HURRICANE CITY UTAH

Hurricane Planning Commission Meeting Agenda

July 25, 2024
5:00 PM

PRELIMINARY SITE PLAN CORAL CLIFF FAMILY FUN CENTER

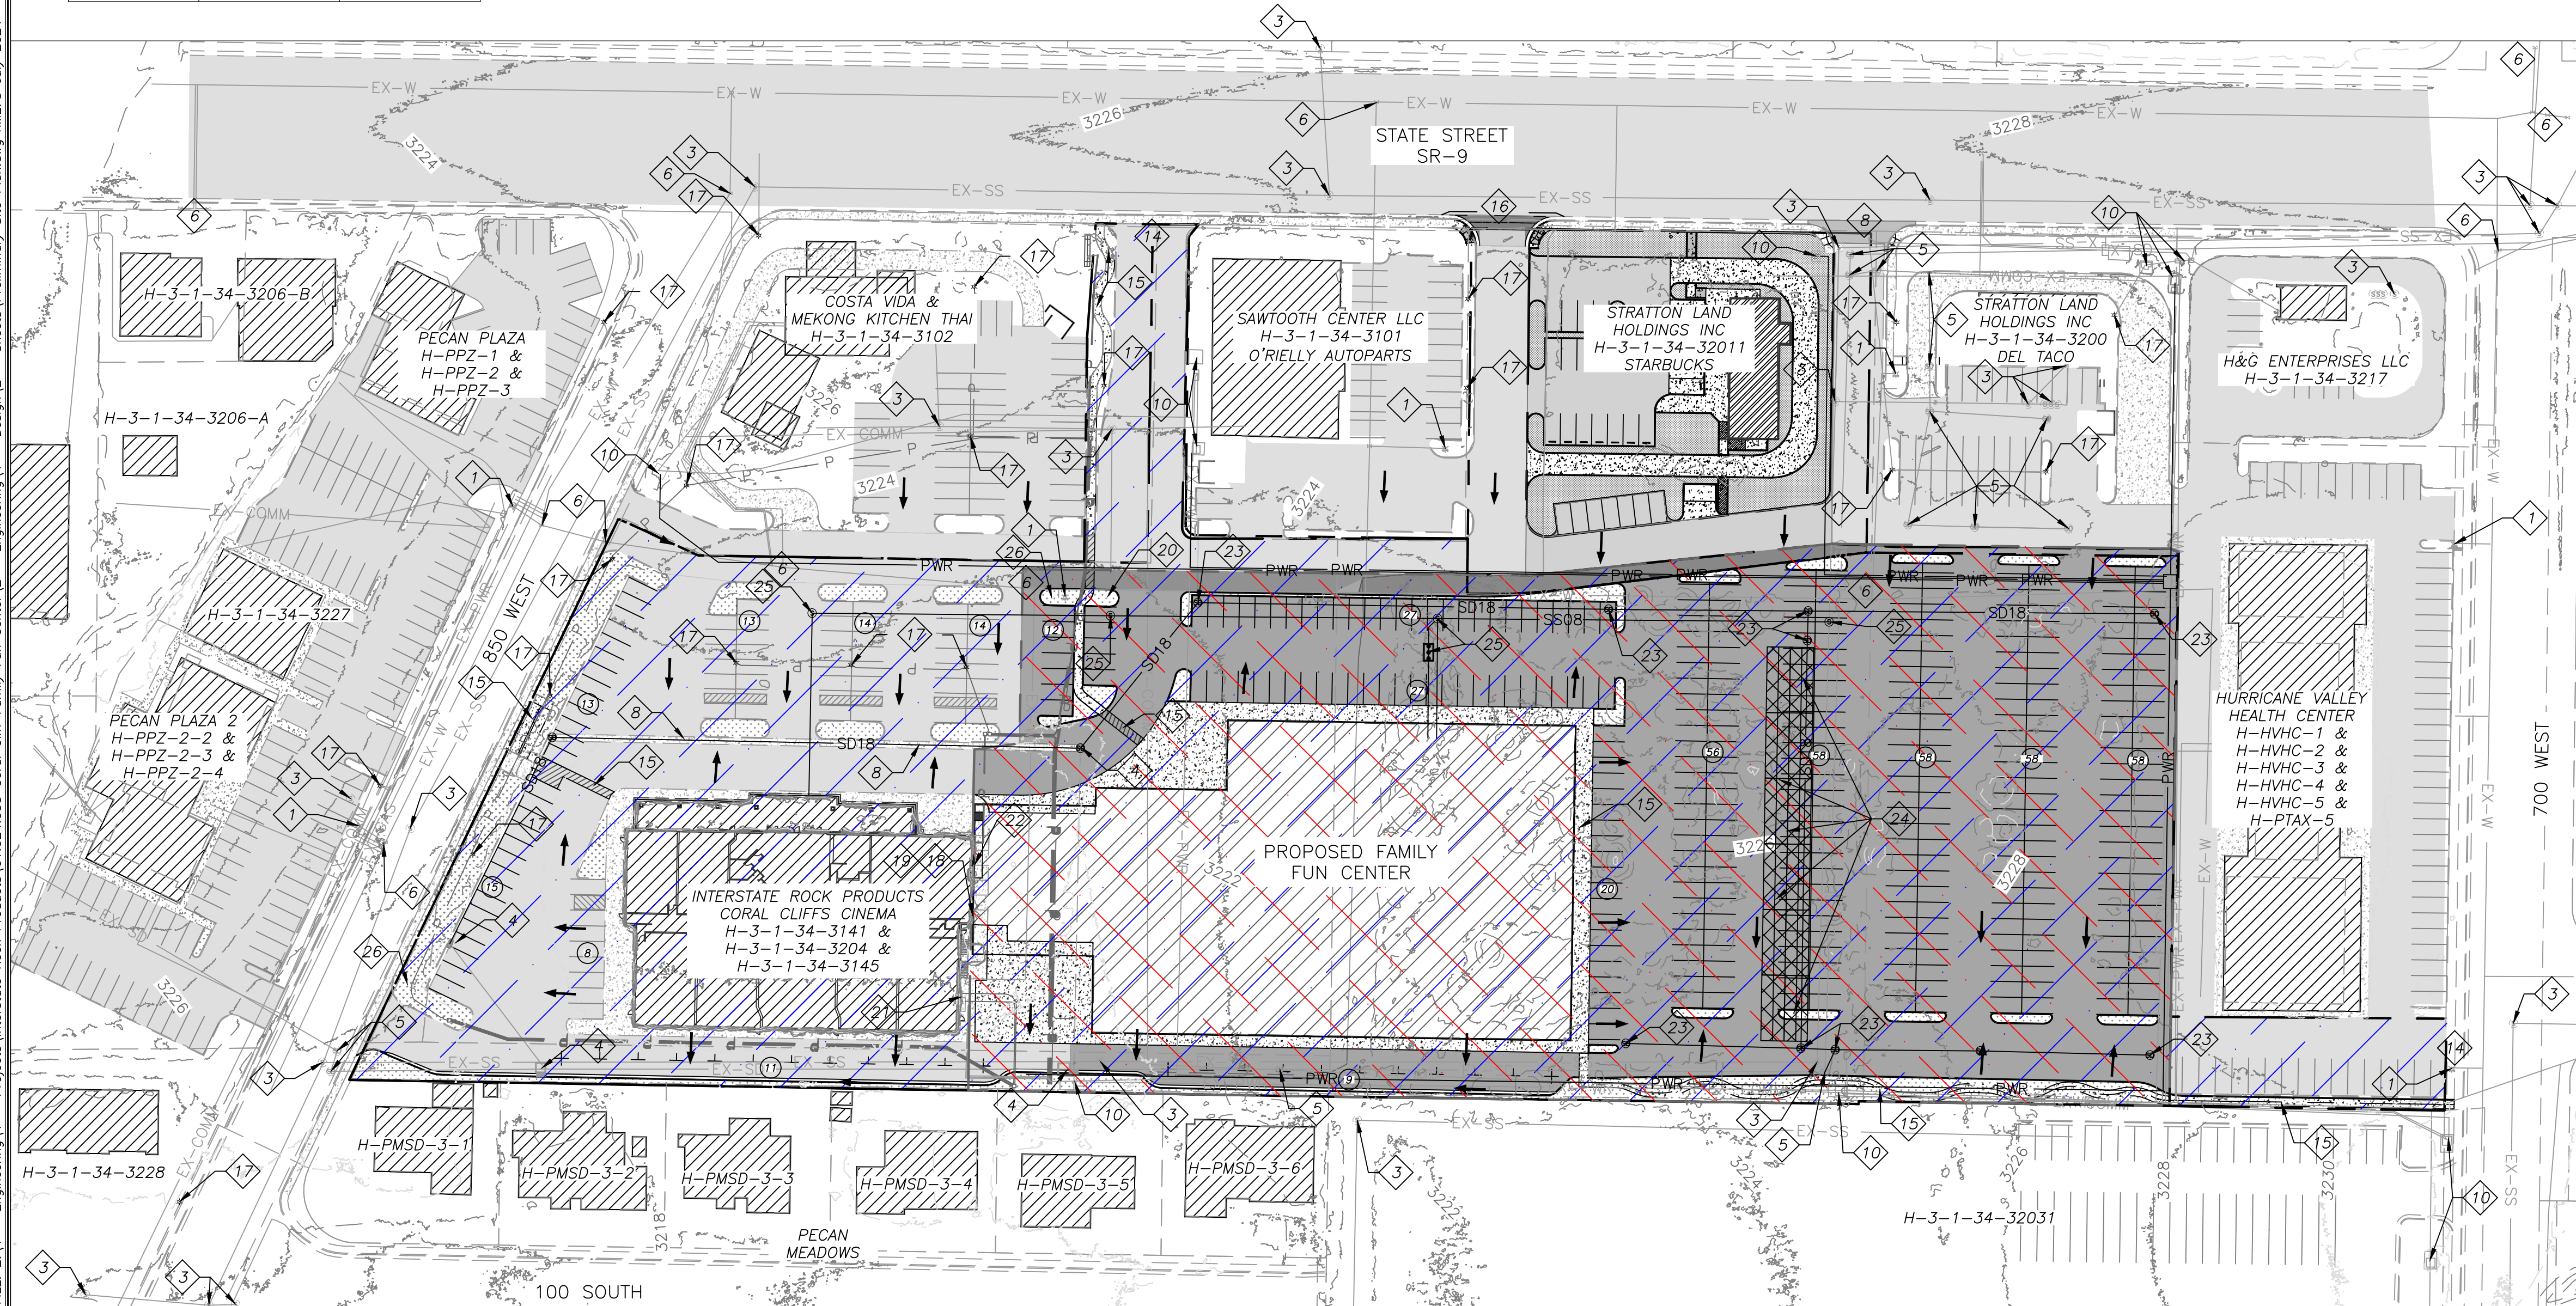
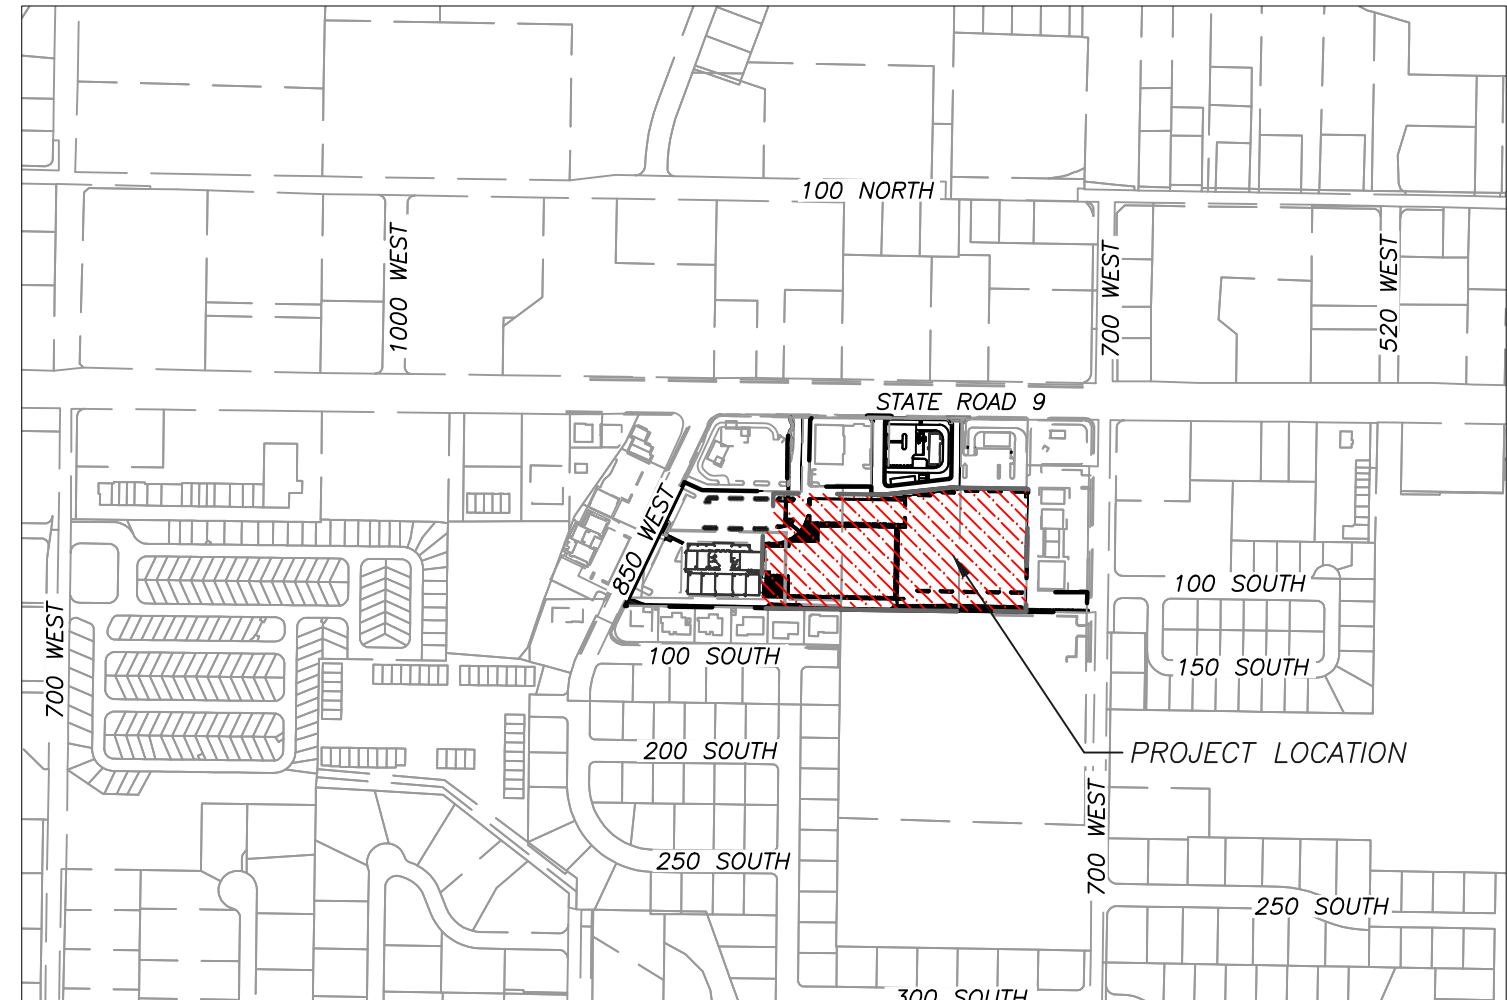
6. **Engineering:** Engineering recommends approving the preliminary site plan with good faith that the issues identified by the attached redlines can be coordinated between the applicant and city staff during construction plan review. Nevertheless, commentary from the Planning Commission on how existing ordinances should be interpreted would be appreciated. Record of survey and draft deeds must be submitted for review with the site construction plans (USC 17-23-17). Because a record of survey is nearly a final plat and the anticipated number of deeds will be significant, engineering would encourage the applicant to consider using a final plat to exchange properties and create easements. Hurricane City will need public utility easements to protect utility alignments (HCS 3.8.4). Submit draft easements for review with the construction plans and record of survey. Although there's a separate site plan application for the Starbucks site, each site must be considered together by the applicant (i.e. a change to one site plan will likely spill into the next, such as efficient traffic movement patterns and pedestrian circulation, HCC 10-33-4 & HCC 10-33-5(A & H), respectively). Vehicles must traverse Hurricane City property to access the easternmost parking stalls. an existing access agreement (#20210081734) must be renegotiated. Deliveries (loading and unloading) and solid waste collections don't seem to be shown (HCC 10-33-5(B & L). It appears pedestrian connectivity northeast of the new building could be improved. The ordinance HCC 10-33-5(H)(1) specifies, "pedestrian paths shall connect within the project, and should connect to adjacent properties" staff would appreciate commentary from the Planning Commission. The existing access on 700 W (southern access on Hurricane City's property) has an unacceptable offset with 100 S (table 12 Hurricane City Transportation Master Plan, pg. 105). Reconstruction of the access is discouraged until it could be aligned with 100 S. Proposed sanitary sewer must be 10' minimum from other utilities (ACSSD std 4.2.3(A)(3)). Observe a 5' minimum horizontal clearance for proposed storm drain (see HCS 3.5.1). It's unclear how existing utilities will be restored to the movie theater (HCC 10-7-10(D)(2)(a)(5)). How many utility services are needed? The applicant should indicate where the southern neighbor can potentially obtain cross access. HCS 3.2.4.2(G) specifies that "new access locations created by development shall be unified whenever possible to create the fewest number of access points onto arterials or major collectors. Cross use agreements shall be required where necessary." 700 W is a major collector and State Street is a major arterial. At its current width the drive aisle south of the theater and family fun center must be one-way (HCC 10-34-7(B)(2))

- b. The proposed site plan shows that 476 parking stalls are provided and calculates that 465 parking stalls are required for both proposed uses on site. Staff would recommend the applicant provide more detail on how those calculations were done. Staff has no concerns on the adequacy of parking for this development and believes that a shared parking arrangement or parking requirement modification as laid out in HCC 10-34-9 could be appropriate for this development.

- 5. Considerations for pedestrian connectivity throughout the development and possible connection to the property to the south should be considered as part of the final site plan preparations.
